Y1A, Y1B, Y1C- High-Voltage (HV) Battery Measurements during HV Battery Repair

Advanced Technical Information

Bulletin #: 2518

Figure 1 - 28-module HV Battery measurement points

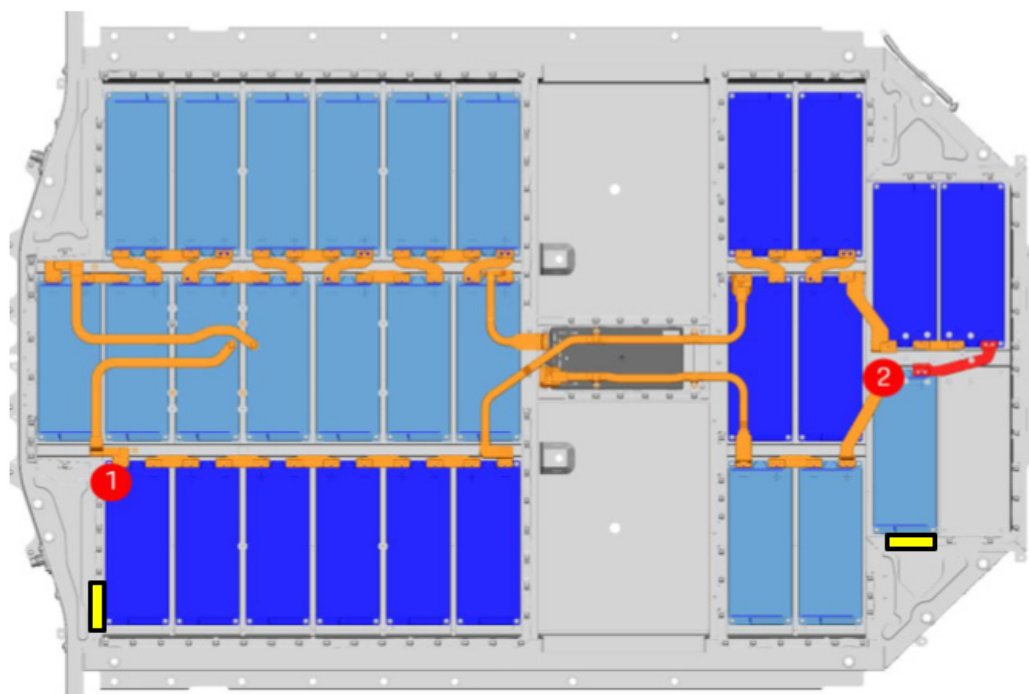
DST Procedure for 28-module Taycan Battery Pack (Figure 1)

- Only two DSTs are to be performed on a 28-module battery pack during repair.
- During a DST, only personnel with a 40 Cal Arc Flash suit and approved PPE may be permitted within the cordoned HV safety zone around the battery pack.

- The busbar indicated in red must be removed prior to measurements at either point.
- Perform an IR test at points 1 and 2 before the DST at those points.

- Perform a DST only at points 1 and 2 shown below for each repair scope.
- The yellow boxes in Figure 1 designate the sections of laser clean surface (silver stripe) to contact using the negative probe to ground the dielectric strength tester. This method ensures consistency in testing.

- Also perform IR tests at points 1 and 2 after a DST, with the negative probe also on the surface designated by the yellow boxes.
- If the DST at measurement point 1 fails, remove busbars and CMC connections from each module shaded in dark blue for further IR testing as described in the following *Updated IR Measurement Procedure* sections.

- If the DST at measurement point 2 fails, remove busbars and CMC connections from each module shaded in light blue module for further IR testing as described in the following *Updated IR Measurement Procedure* sections.

- EXAMPLE: Point 1 passes DST and point 2 fails.
 - Perform IR tests on each light blue module in the failing section (In this example, section 2). No additional work is required for the passing modules in section 1.

Figure 2 - 33-module HV Battery measurement points

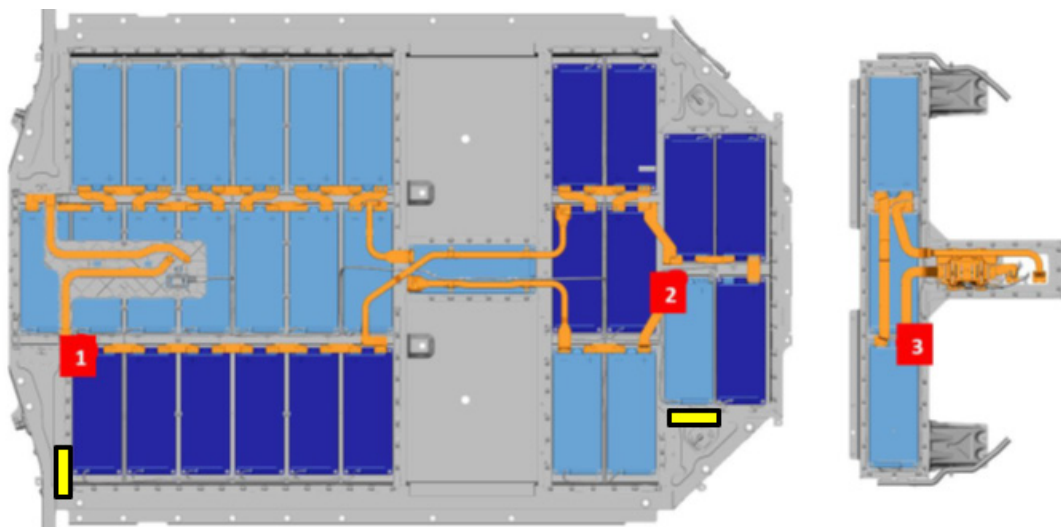
DST Procedure for 33-module Taycan Battery Pack (Figure 2)

- Only a total of three or four dielectric strength tests are to be performed on the 33-module battery pack during repair, depending on scope.
- If removed, the upper "T" Section should be placed aside on a VAS 6762/44 Insulating mat during testing.

- Perform an IR test at points 1, 2 and 3 before the DST at those points.
- Perform a DST only at points 1, 2, and 3 for any repair scope involving the lower-level modules.

- Repair scopes in only the upper "T" section require an initial DST (in addition to the points in figure 2) at the mid-pack fuse as shown in step 3.9.3 of Safety test after assembly work on the high-voltage battery with 33 modules in WM 270803A5. If the DST fails, proceed with removing the lower lid and perform DSTs at points 1, 2, and 3 as identified below.

- The yellow boxes in Figure 2 designate the section of laser clean surface (silver stripe) to contact using the negative probe to ground the dielectric strength tester. This method ensures consistency in testing.

- Perform IR tests at points 1, 2, and 3 after a DST, with the negative probe also on the surface designated by the yellow boxes.
- If the DST at measurement point 1 fails, remove busbars and CMC connections from each module shaded in dark blue for further IR testing as described in the following *Updated IR Measurement Procedure* sections.

- If the DST at measurement point 2 fails, remove busbars and CMC connections from each module shaded in light blue for further IR testing as described in the following *Updated IR Measurement Procedure* sections.

- If the DST at measurement point 3 fails, remove busbars and CMC connections from each module in the upper "T" section for further IR testing as described in the following *Updated IR Measurement Procedure* sections.

- EXAMPLE: It is possible for battery to have point 1 pass, point 2 pass, and point 3 fail the DST. It would then only be required to perform further IR tests on each module in the upper "T" section. No additional work would be required for the passing lower sections.

Figure 3 - IR Test at Positive Terminal

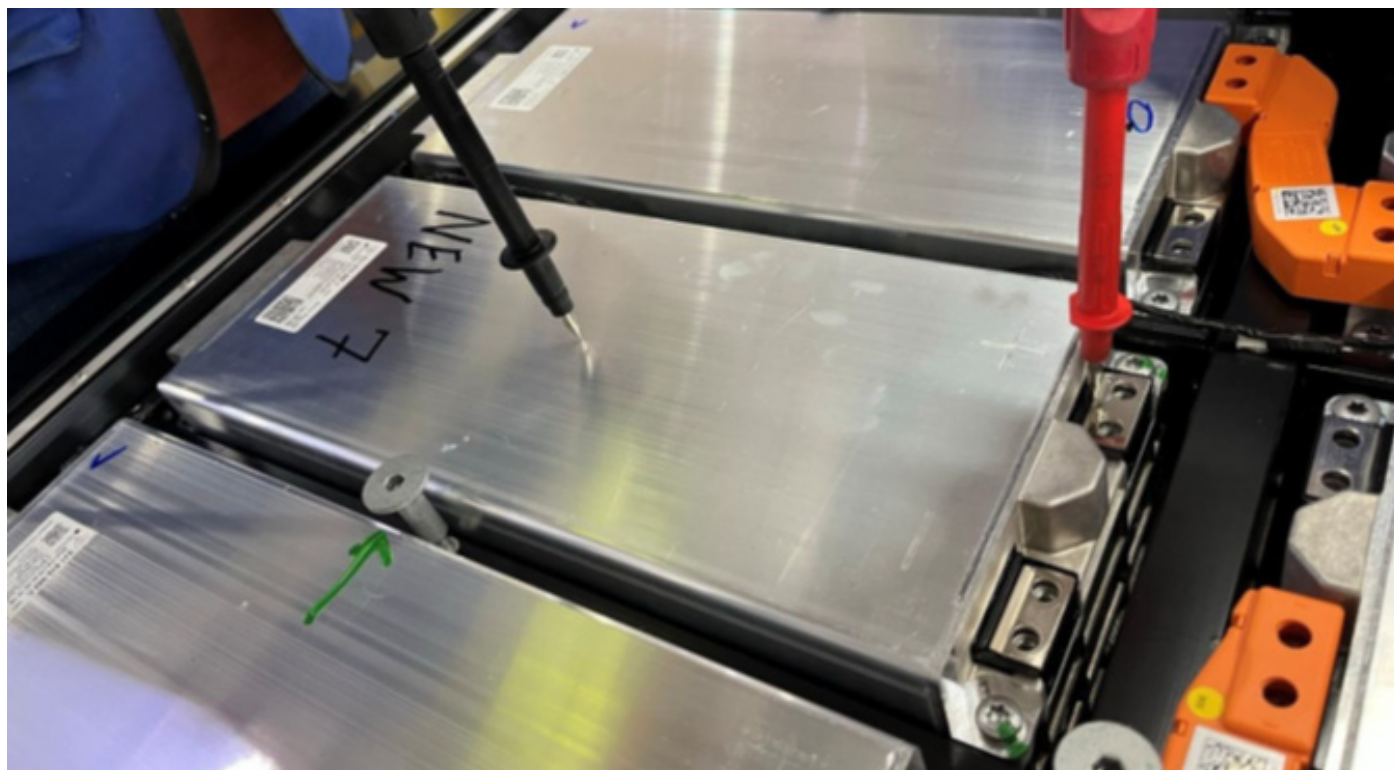
Module IR Testing Procedure: Positive Terminal (Figure 3)

- Place the red probe at the edge closest to the black plastic surrounding the terminal to avoid scratching the conductive surface.
 - CAUTION: pay attention to the angle of the red probe in this case. Avoid contact with the side of the probe and the edge of the module housing. Use a plastic probe cap to expose only the tip of the probe if available.
- Maintain contact with the black probe to the module case in the center. Ensure that the module casing surface is clean at the point of contact.
- The equipotential bonding cable is not suitable as a ground point during this test. Use both straight probes directly on the module to isolate conductive influences.

Figure 4 - IR Test at Negative Terminal

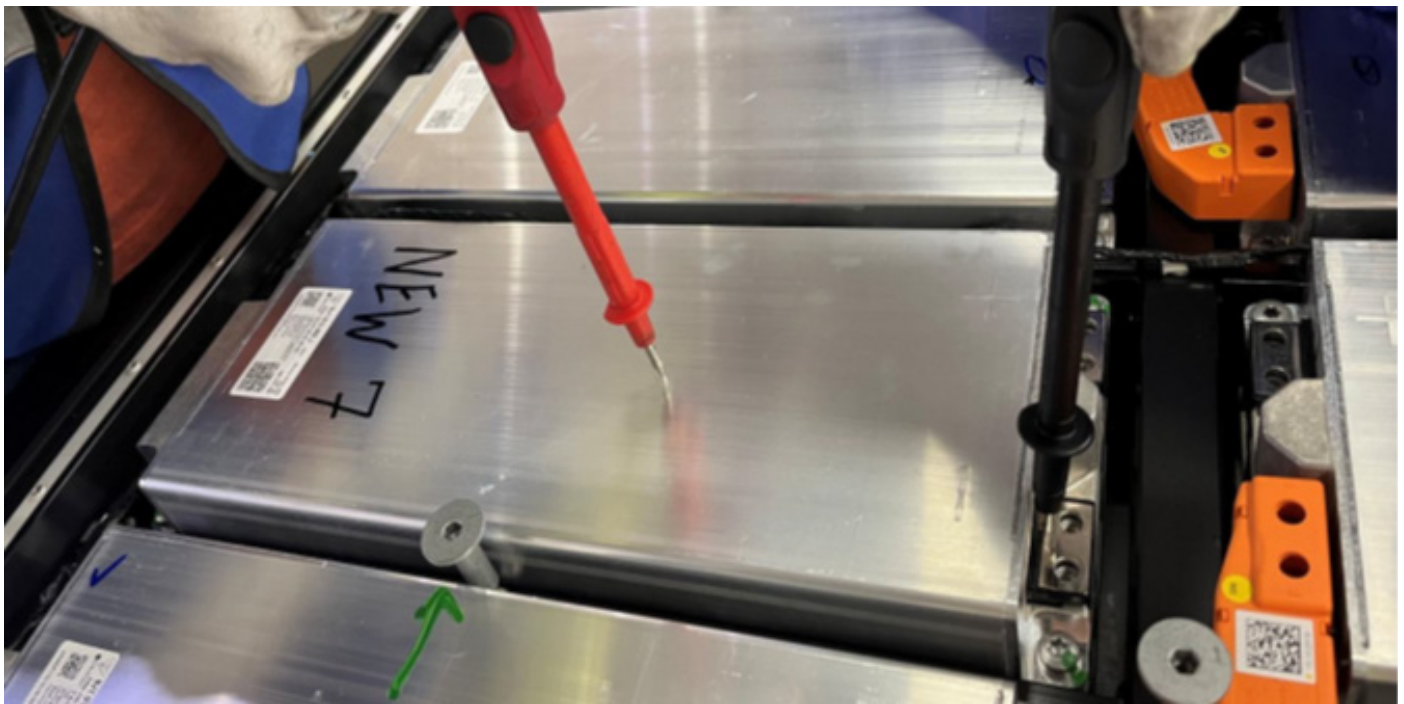
Module IR Testing Procedure: Negative Terminal (Figure 4)

- Place the black probe at the edge closest to the black plastic on the terminal to avoid scratching the conductive surface.
 - CAUTION: Pay attention to the angle of the black probe in this case. Avoid contact with the side of the probe and the edge of the module housing. Use a plastic probe cap to expose only the tip of the probe if available.
- Maintain contact with the red probe to the module case in the center. Ensure that the module casing surface is clean at the point of contact.
- The equipotential bonding cable is not recommended as a ground point during this test. Use both straight probes directly on the module to isolate conductive influences.

Figure 5 - Insulation resistance measurement in PIWIS Tester

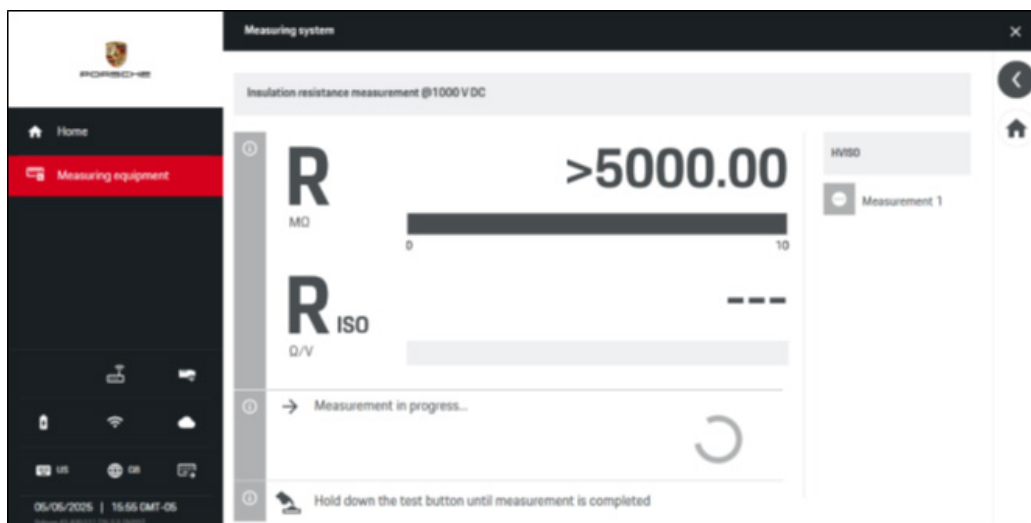
IR Testing Pass/Fail Criteria (Figure 5)

- Shown below is an example of passing test result of >5000 MΩ. This is the reading when IR measures above the 500 MOhm measuring threshold.
- If the first IR test on either module terminal fails, but the second one passes, the module is okay and should not be replaced.
- If any second terminal IR test shows a number below 500 MΩ, this is considered a failure.
- Report any failures to PCNA Technical Support via PRMS for approval of any additional module replacements during repair. Specify the total count of replaced modules for a repair vs replacement decision.
- Document these results in the "Module insulation Resistance Template" Excel file attachment and attach to the PRMS Ticket and repair PCSS entry.
